**Date:** April 22, 2019  
**To:** Planning Board  
**From:** Lincoln Daley, Community Development Director  
**Subject:** SP2019-01 Milford DG Series, LLC, for the property located at Tax Map 6, Lot 14-1. Major Site Plan Application to construct a 9,320 square foot retail store with associated parking, drainage, and site improvements within the Integrated Commercial – Industrial Zoning District and West Elm Street Overlay District.

**Re: Proposed Retail Development  
30 Wilton Road, Milford, NH – Map 6, Lot 14  
Response to Community Development / Planning Comments**

PRIVACY FENCE DETAIL

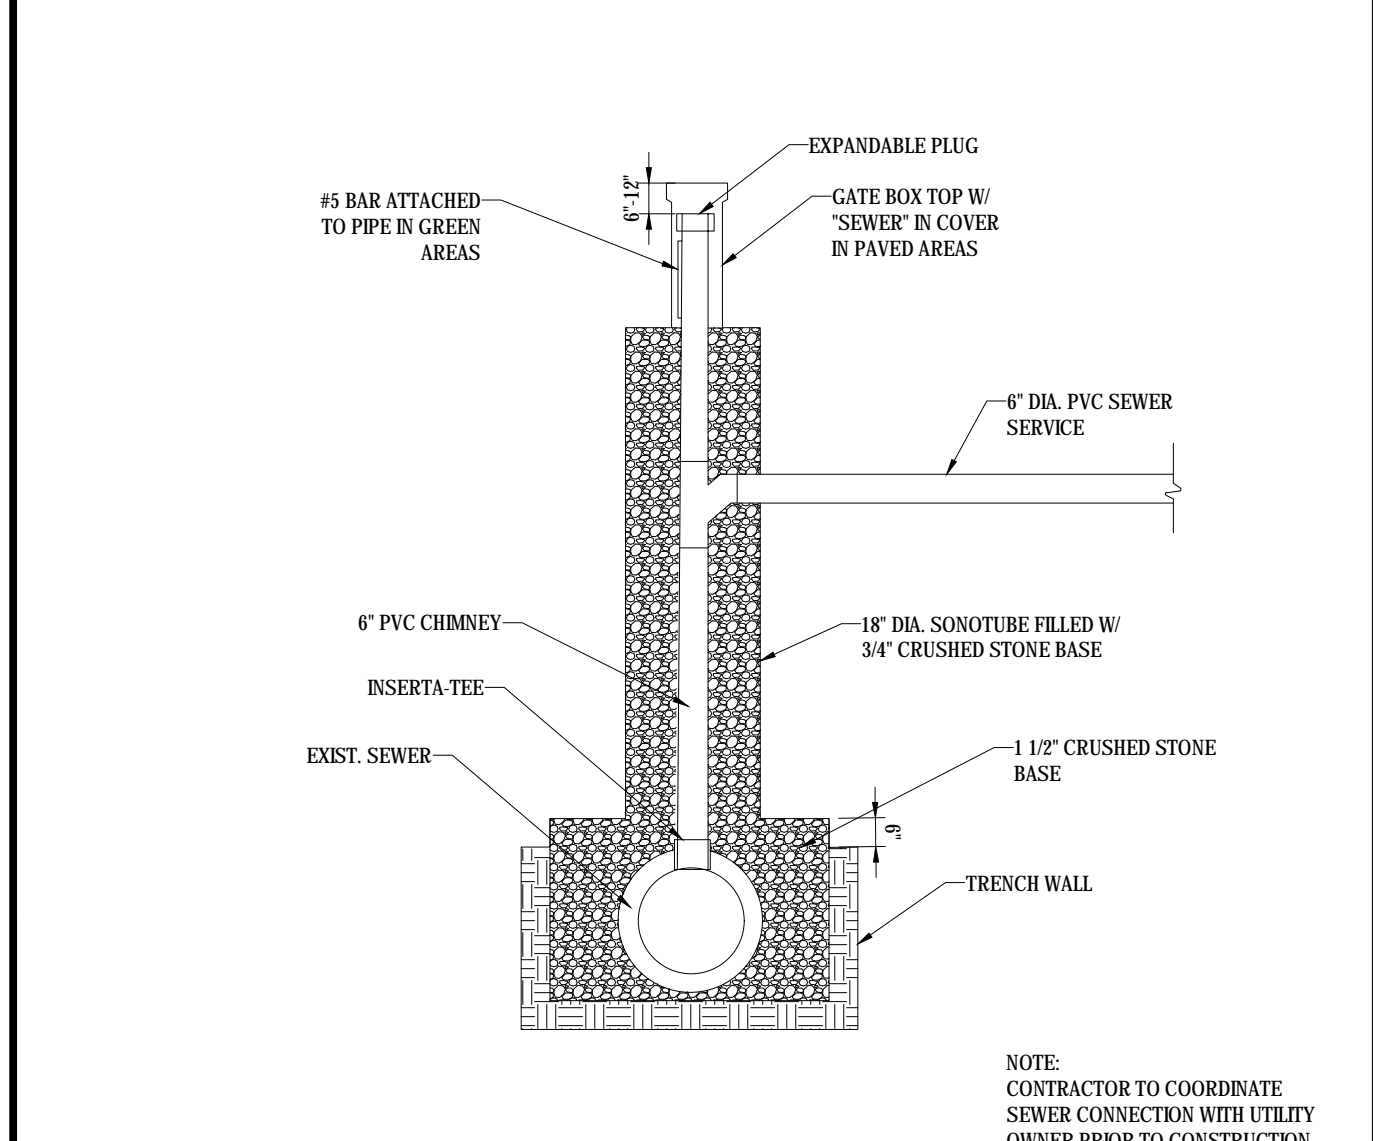
4. Sheets 4 and 9. The plan displays an 8' tall fence extend along on the western property border to the southwest corner of the building. It is recommended that the fence be extended to the property line of the residential abutter to provide further visual mitigation of the building and improve the safety/security between the two properties.

**Comment 4:** *The fence has been extended an additional 35'. However, the 8' tall fence is categorized as a structure and must adhere to the setback requirements of the ICI district (15-foot side setback) unless granted a special exception from the Board of Adjustment.*

**Addressed** – *A six foot high fence has been added.*

**Response 4:** **As discussed with the Planning Board at their March 26, 2019 hearing, the proposed fence along the western property boundary has been revised to be six (6) feet in height, as shown on the enclosed Site Development Plans.**
